SUNLIGHT HOUSE
DESIGN AND ACCESS STATEMENT
OFFICE REFURBISHMENT
140958/LO/2024

This document is a follow up to the submitted Listed Building Application for the office refurbishment at Sunlight House, Manchester, M3 3HP.

This LBC application only relates to Floors 1 & 6, previously occupied areas, the proposal follows the same principles set out in the previous application for all other floors.

LEVEL 6 FLOORING

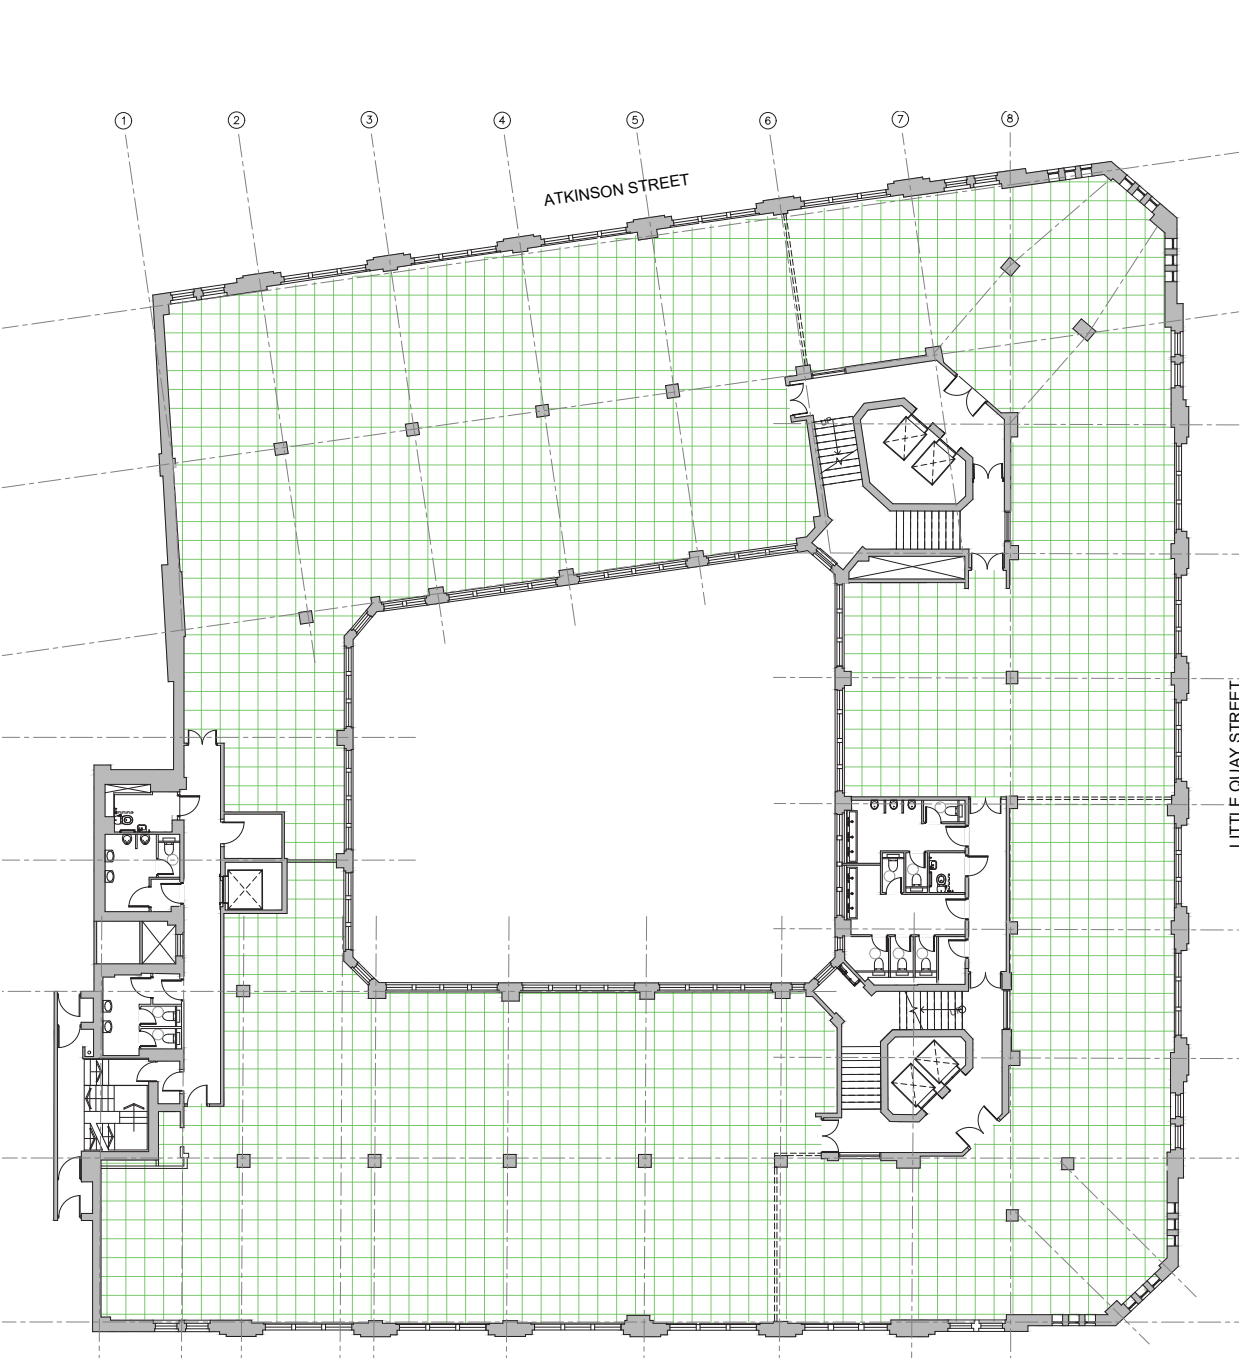
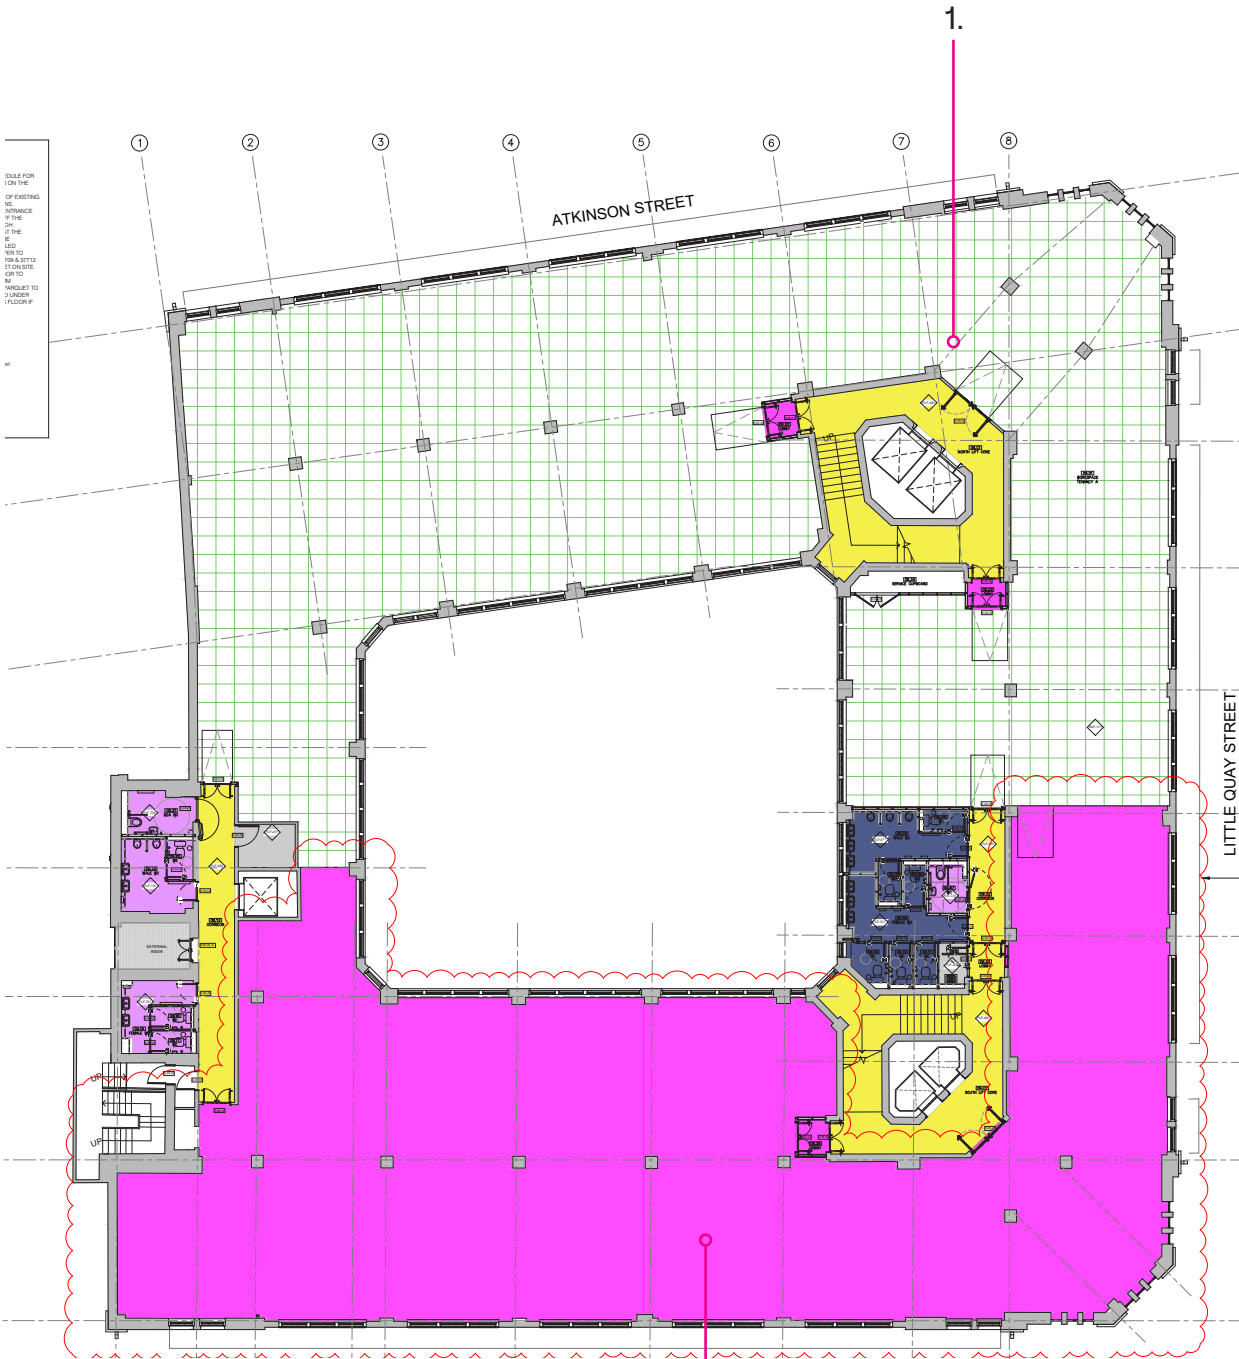
Following the conversation and invastigation on parquet condition, there will be more refurbished parquet exposed on Level 6.

- 1. Raised Access Floor
- 2. Refurbished Parquet floor

LEVEL 1 AND 6 BULKHEAD DETAIL

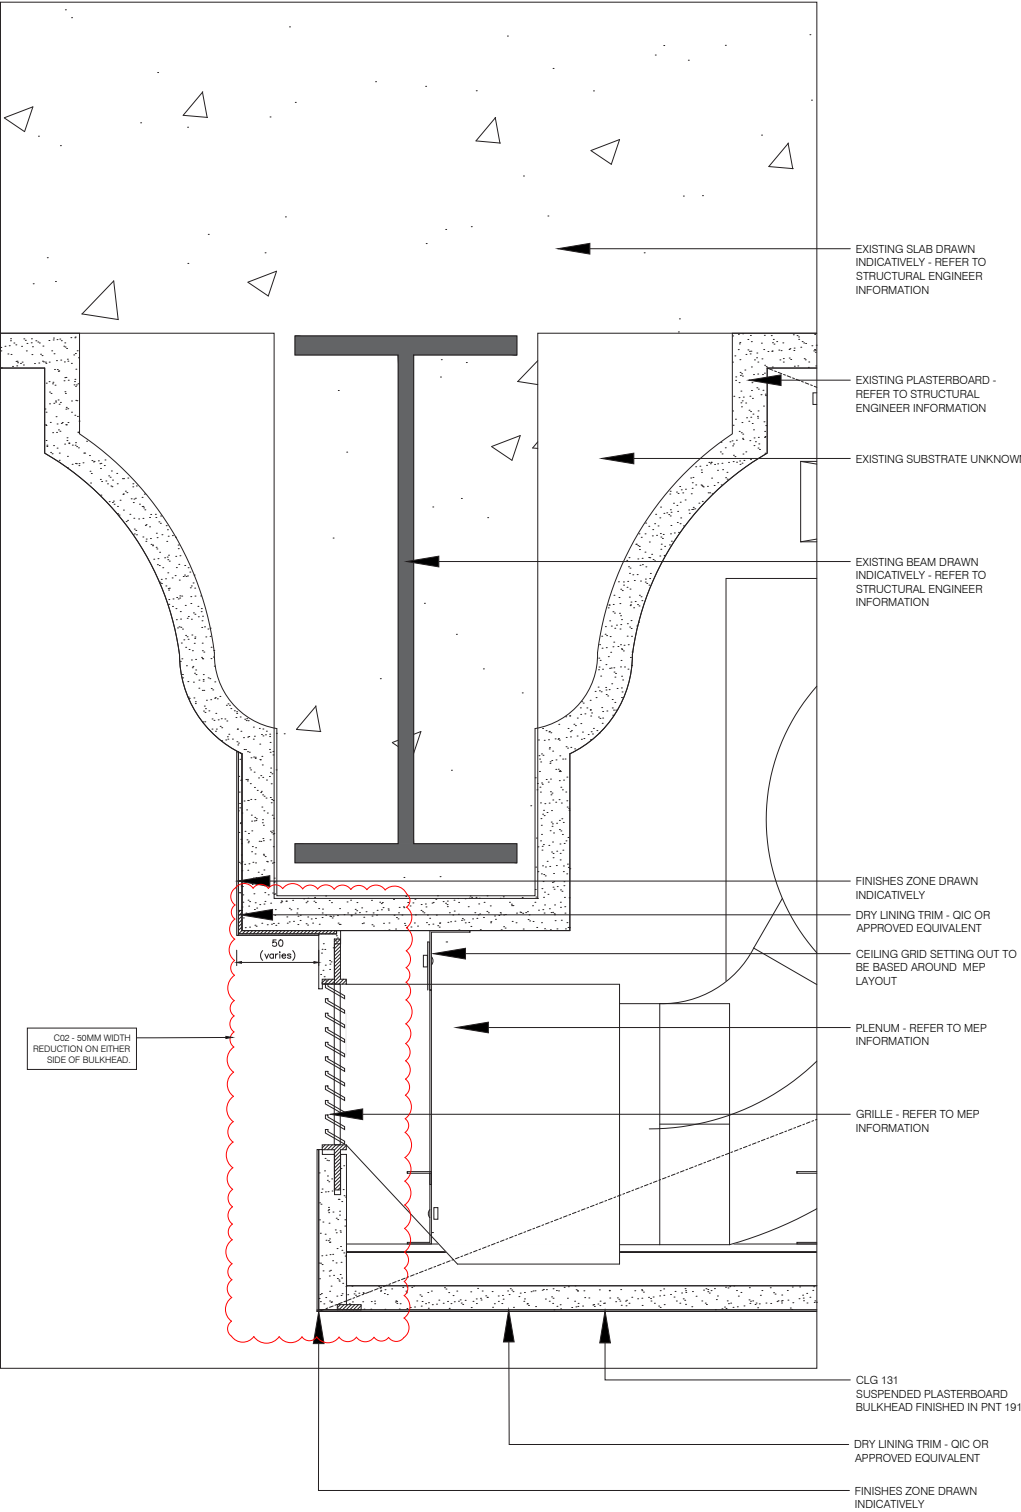
Bulkheads follow existing beam lines. Vertical face of the bulkhead is slightly offset from the beam edge, due to existing beam line variations on site.

01 PROPOSED TYPICAL CONTAINMENT
TYPICAL LEVELS WITH PARQUET FLOOR

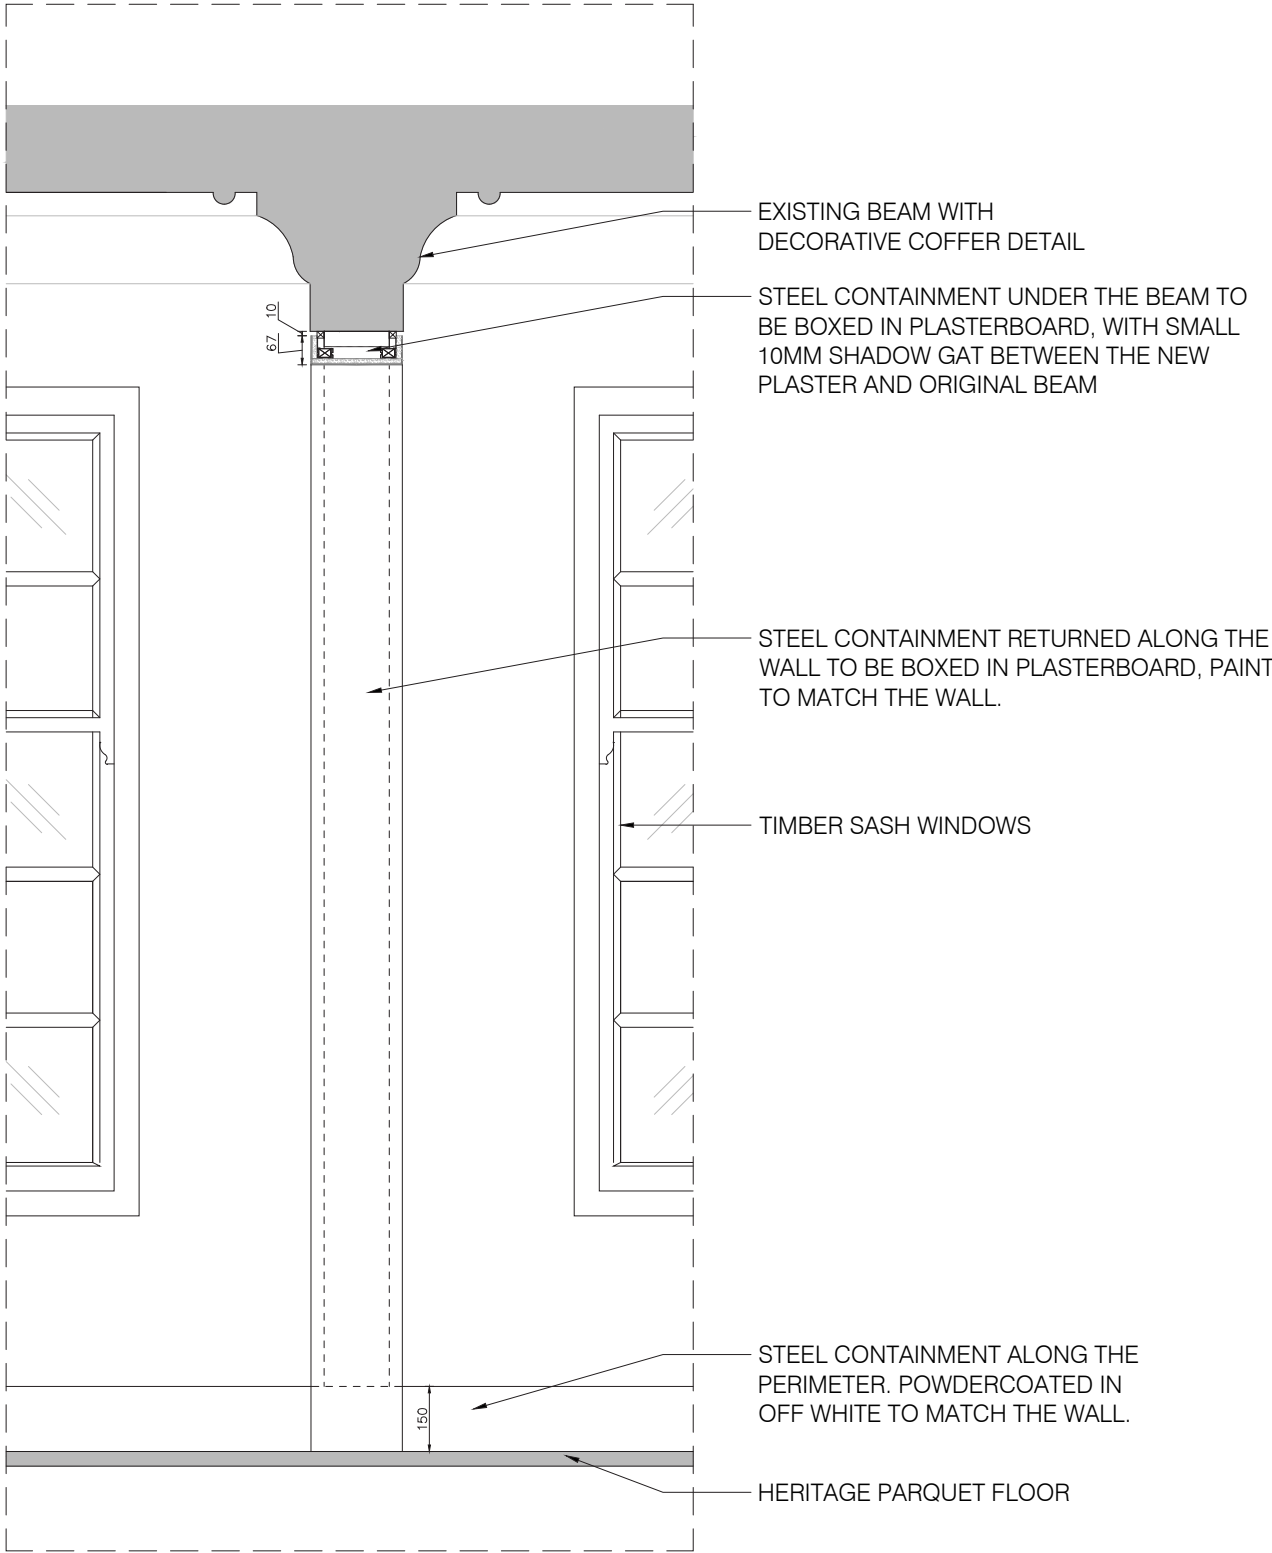
Perimeter power trunking for the units with parquet floor. Containment which runs along the wall and on the underside of the beam to be covered in plasterboard boxing out and painted to match the wall finish.
